15 September 2015

Document No. 147645033-027-L-Rev0

ALLAWUNA FARM WORKS APPROVAL APPLICATION: W5830/2015/1 FURTHER INFORMATION

Figure 1: Leachate pond storage – Monte Carlo simulation using 100 years of rainfall data (maximum storage capacity at freeboard level is approximately 2700 m³).

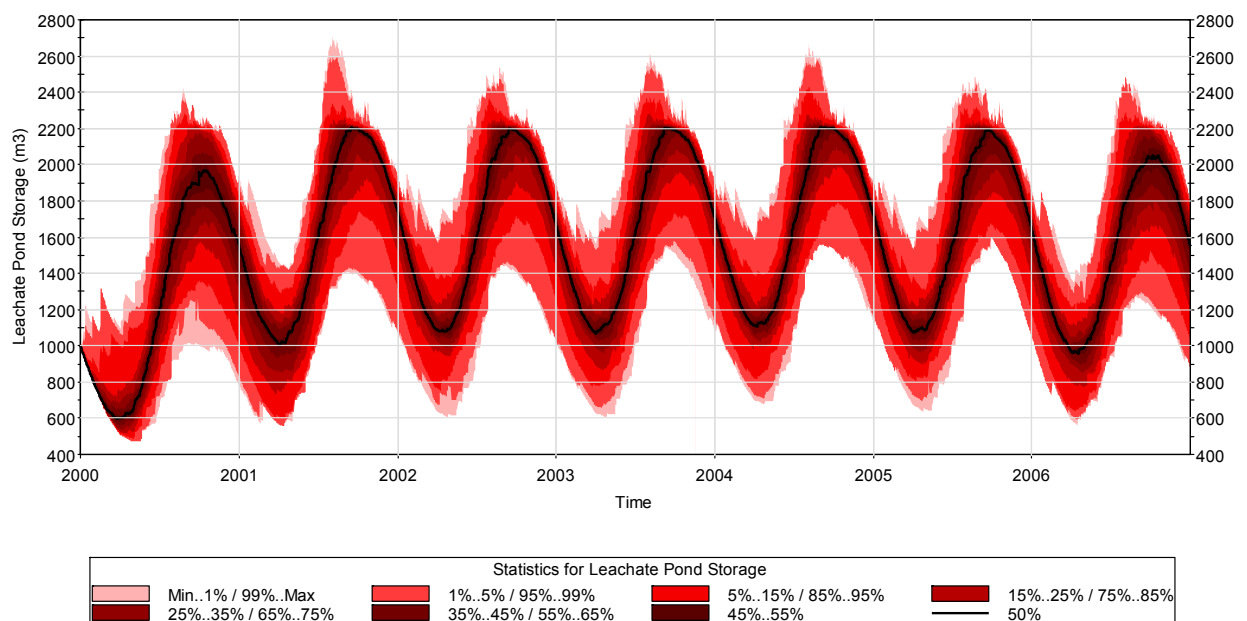
- *no overflow occurs, and*
- *levels are maintained to prevent contents drying out in order to prevent potential residue dust emissions and maintain the integrity of the liner*

A Monte Carlo simulation has been undertaken using the GoldSim model developed for the Allawuna landfill, to investigate if during the 100-year period for which rainfall data is available for the site the leachate pond would overflow. Based on the simulation, overflow of the leachate pond is shown to be unlikely; only one of 100 Monte Carlo realisations showed a maximum level in the leachate pond slightly higher than the freeboard level. The results of the Monte Carlo simulation are shown in Figure 1 and Figure 2 below.

CLIENT SITA AUSTRALIA	PROJECT ALLAWUNA FARM LANDFILL
CONSULTANT Golder Associates	TITLE RETENTION POND PLAN AND SECTIONS
PERTH OFFICE LEVEL 3, HAVELOCK STREET WEST PERTH, WA 6055 AUSTRALIA [+61] (8) 9213 7600 www.golder.com	PROJECT NO. 147645033
	DOCUMENT NO. 016-R
	REV. D 22 of 27
	FIGURE D230

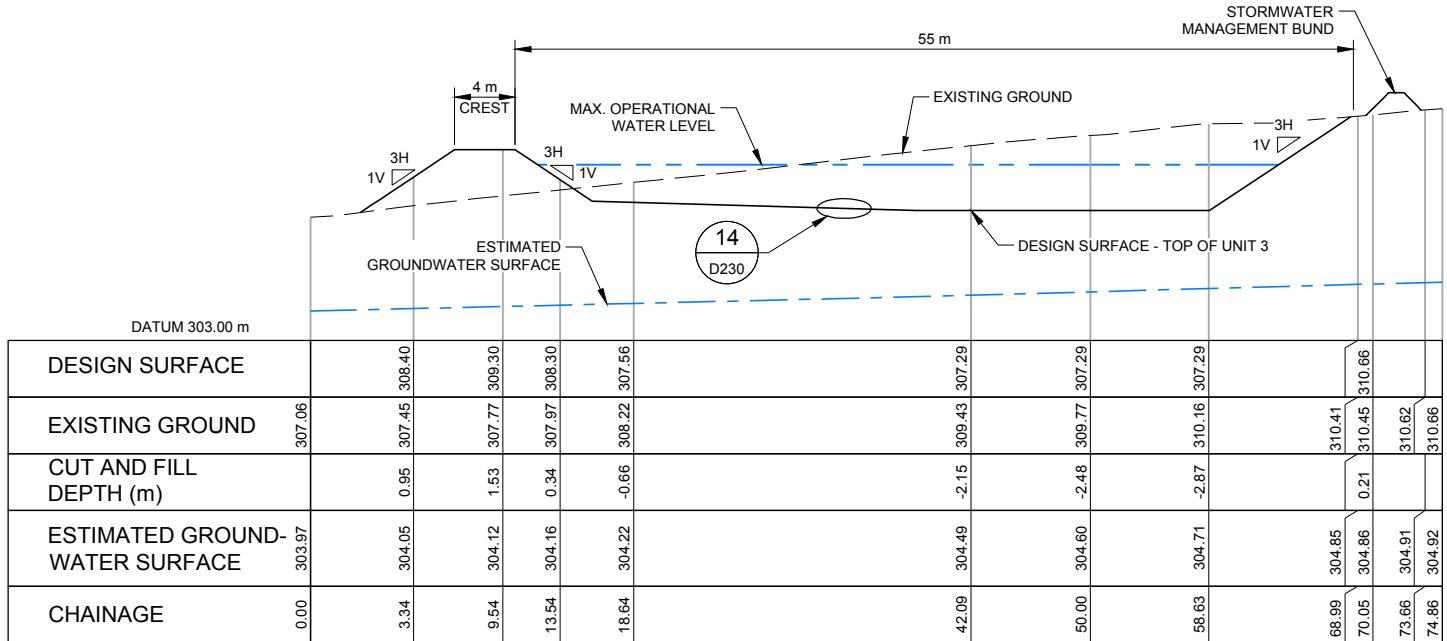
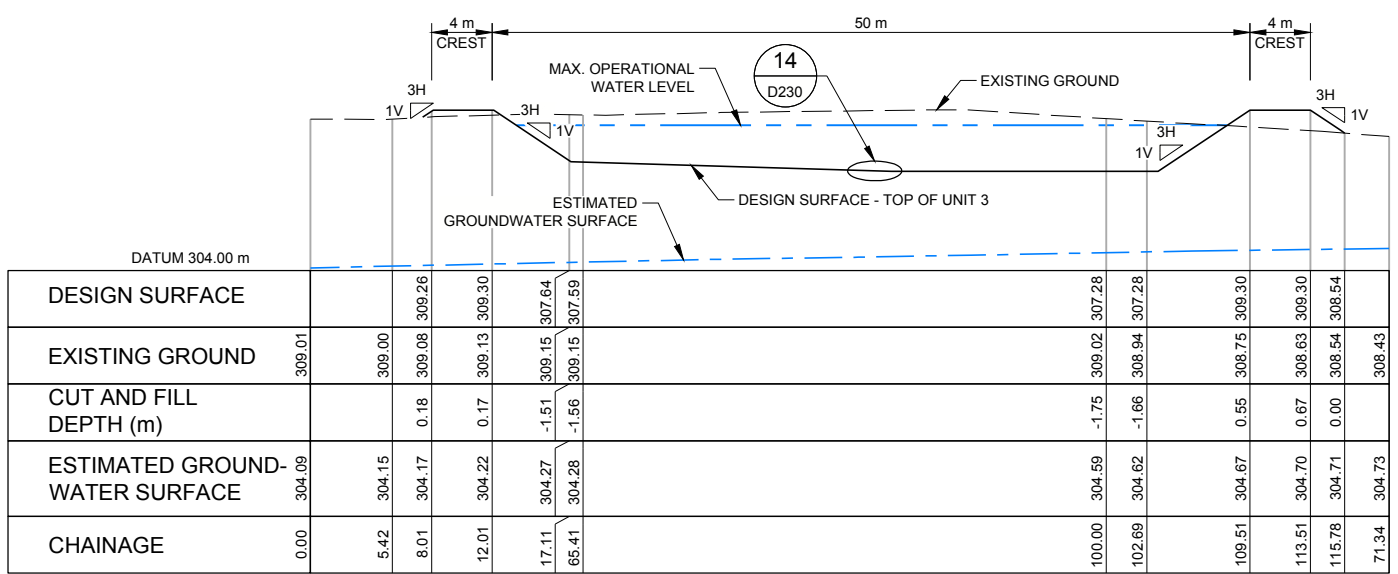
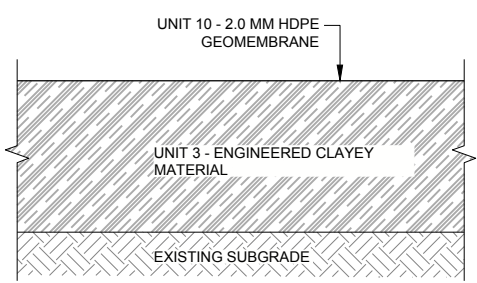
Section 5.2 in the Allawuna Farm Landfill Surface Water, Groundwater and Leachate Management Plan in Appendix E indicates a total pond capacity of 2000 m³. However, Figure D230 in Appendix B indicates a total capacity of 3900 m³, based on the maximum height of the pond. Clarification on the dimensions of the retention pond is required

The minimum separation distance between the base of the retention pond and the highest predicted groundwater level is 2.58 m. This information has been included on Figure D230 Rev D (Refer Attachment B).

PROJECT NO. 147645033 DOCUMENT NO. 016-R REV. D 24 of 27 FIGURE D240

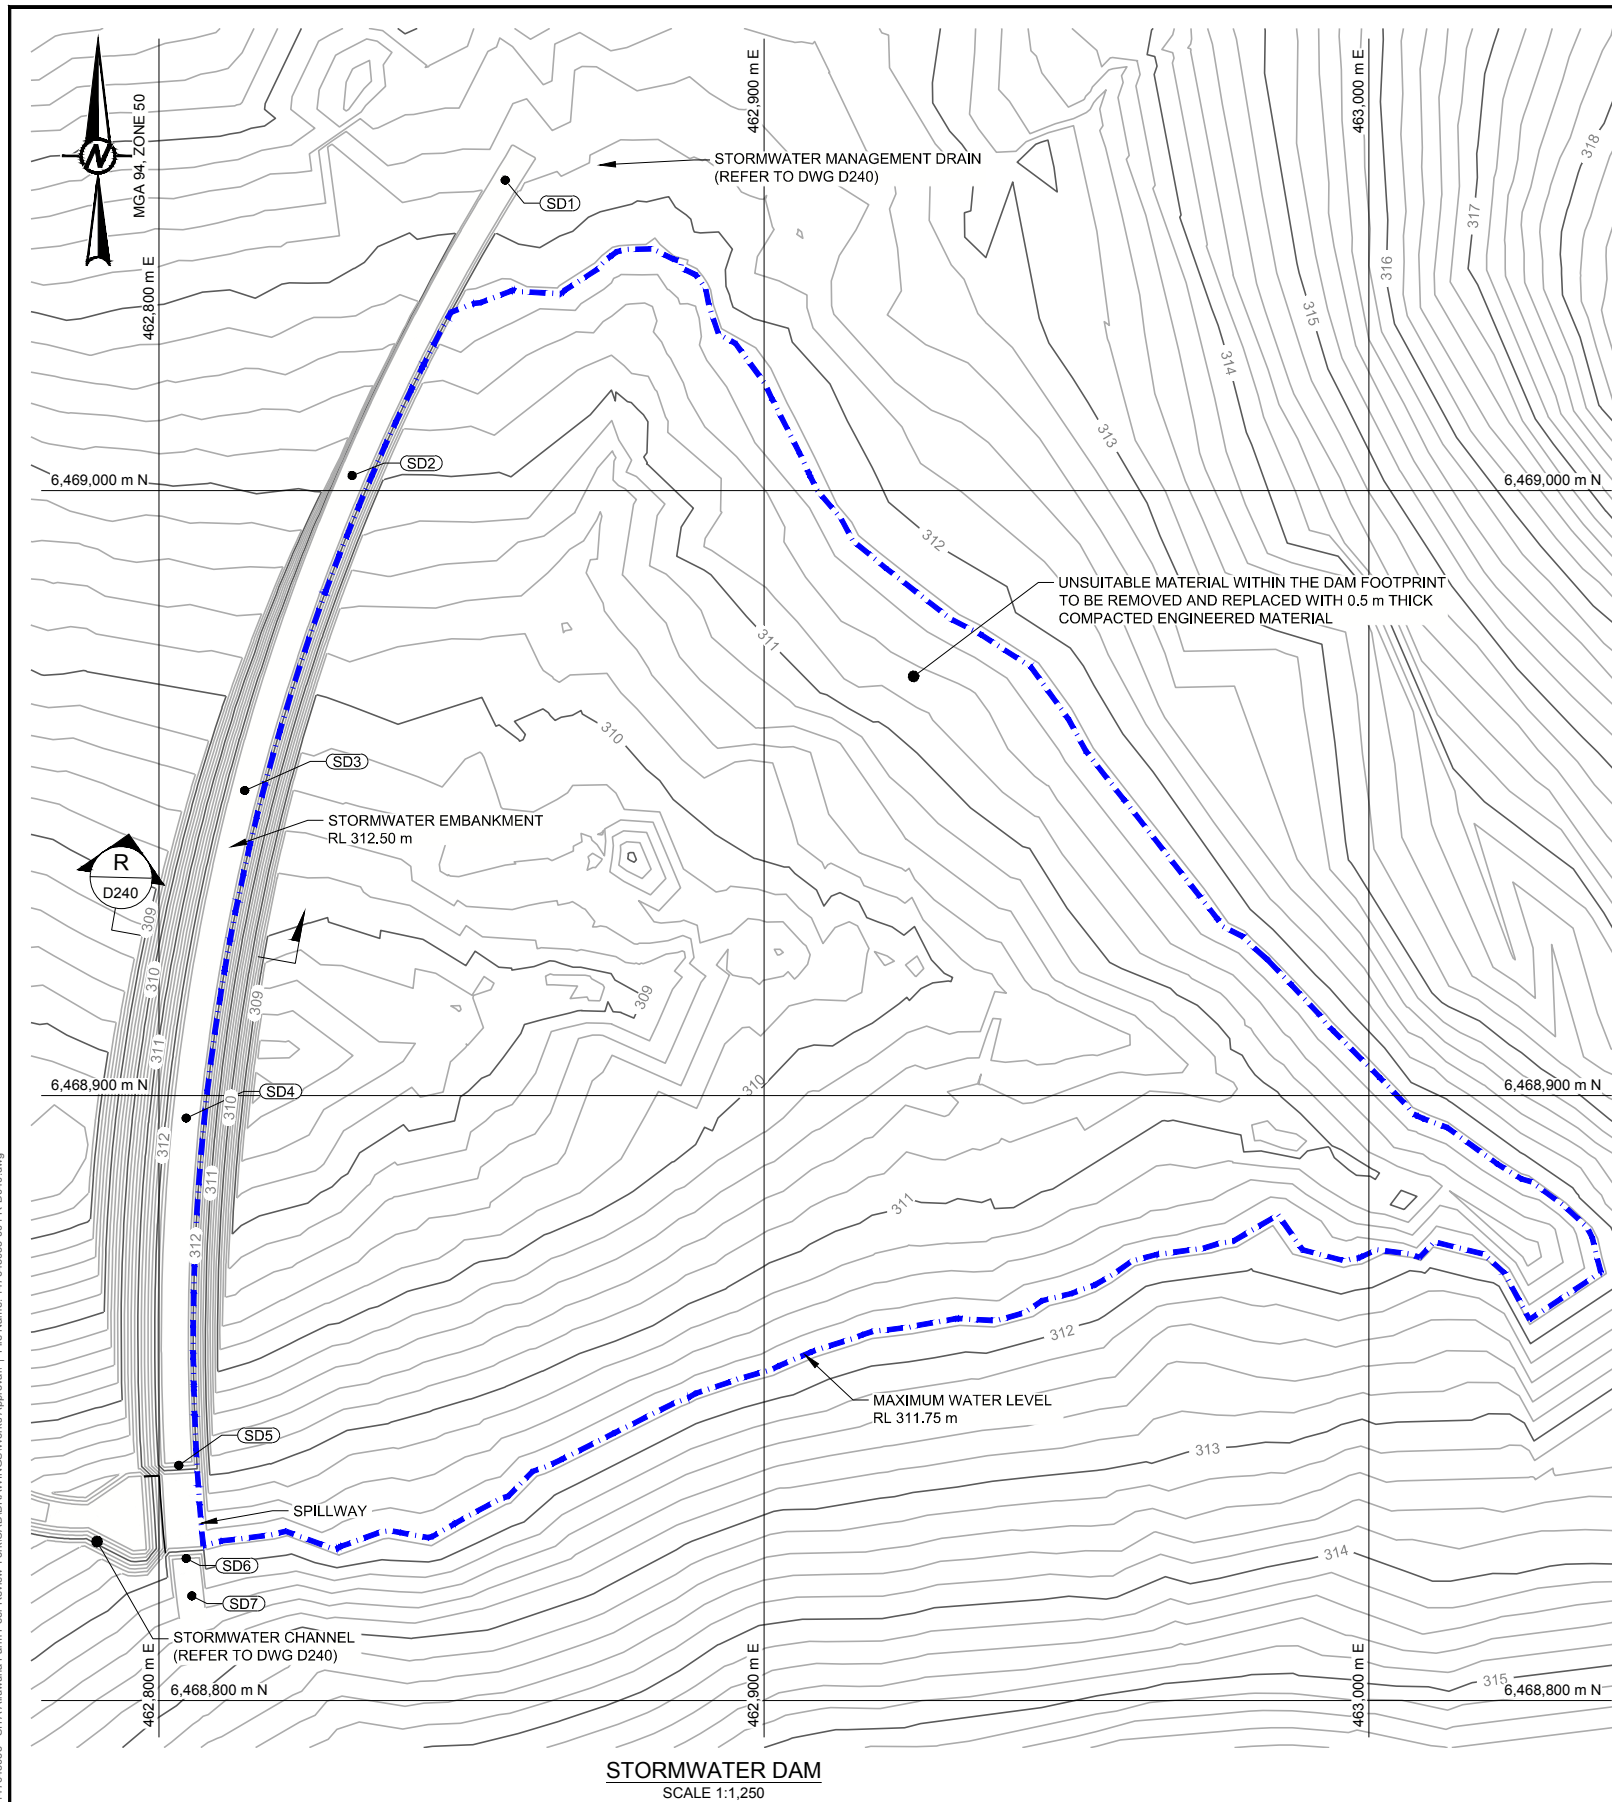
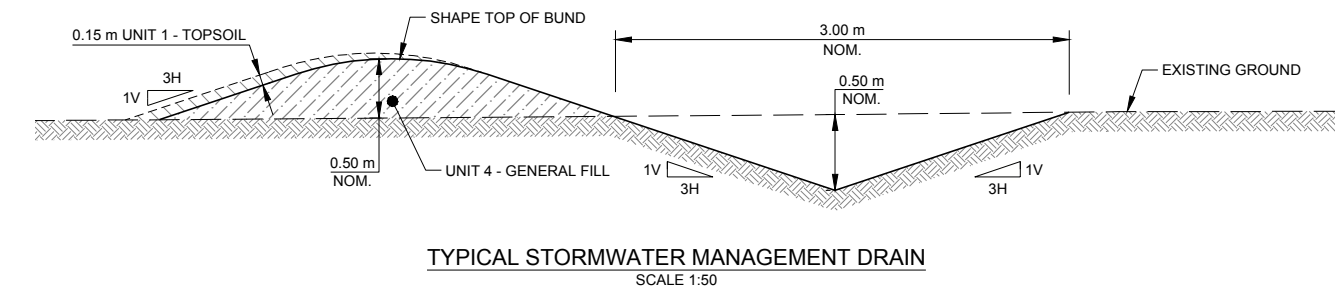
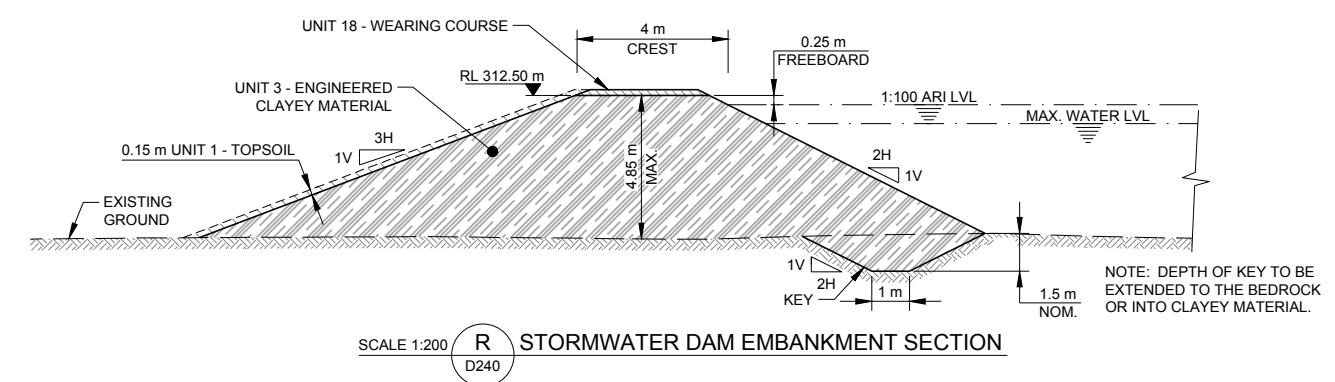
Dimensions of the proposed stormwater diversion drain as depicted in Figure D202 in Appendix B, and

The dimensions of the stormwater drain are shown on Figure D240 (Attachment B). The drain will have a nominal depth of 0.5 m and a nominal width of 3.0 m based on 1V:3H side slopes. The bund along the downstream edge of the drain will be constructed with the material excavated from the drain and have a nominal height of 0.5 m.

PROJECT NO.	DOCUMENT NO.	REV.	FIGURE
147645033	027-L	0	F001

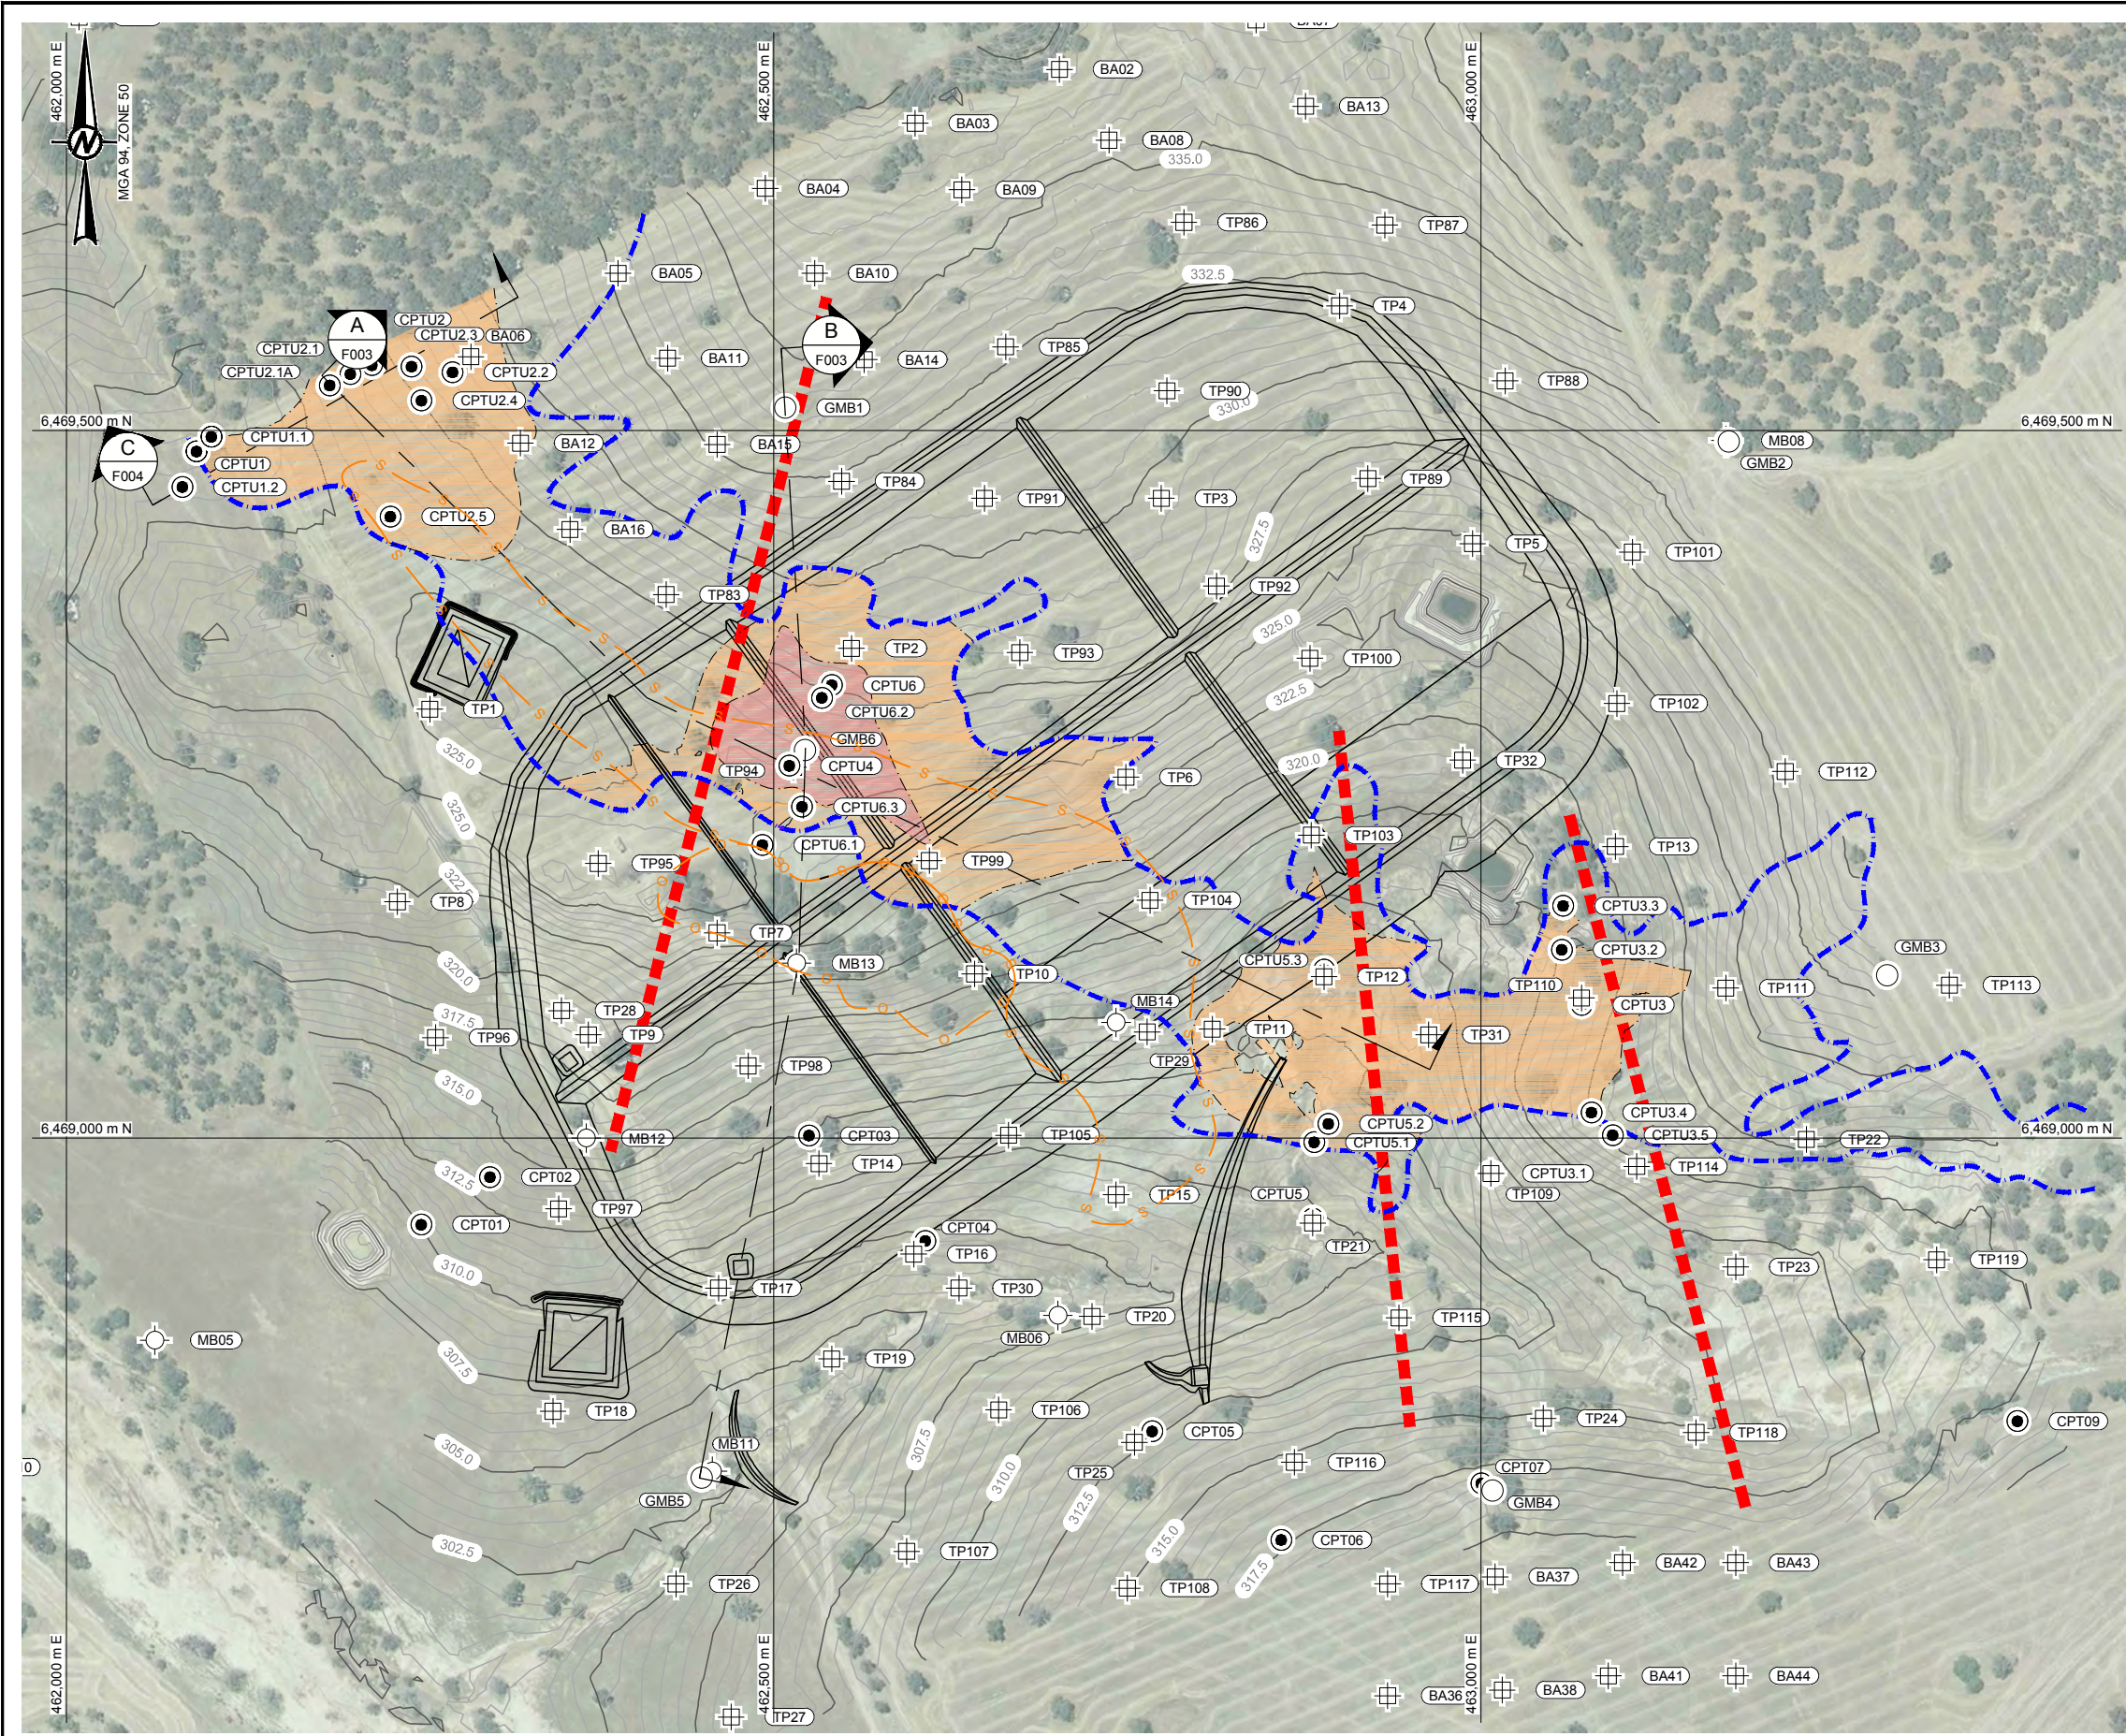
Particular explanation or illustration to map out the extent of the sand deposits within the above feature

Figure 1 shows the location of the cross sections in relation to the landfill site and the extents of the magnetic anomaly.

Figure 1 shows a plan layout of the expected extent of the sandy materials. The sandy materials have been denoted “shallow” and “deep”. Shallow sand is sandy material up to a maximum depth of 1.5 m measured from the current ground surface. Deep sand is sand in excess of 1.0 m and is limited to an area either side of the division wall between Cell 2 and Cell 3. Shallow sand will be removed during the construction of the cells, whilst deep sand will be removed up to a maximum depth of 1.5 m below the finished subgrade level and replaced with compacted clayey material.
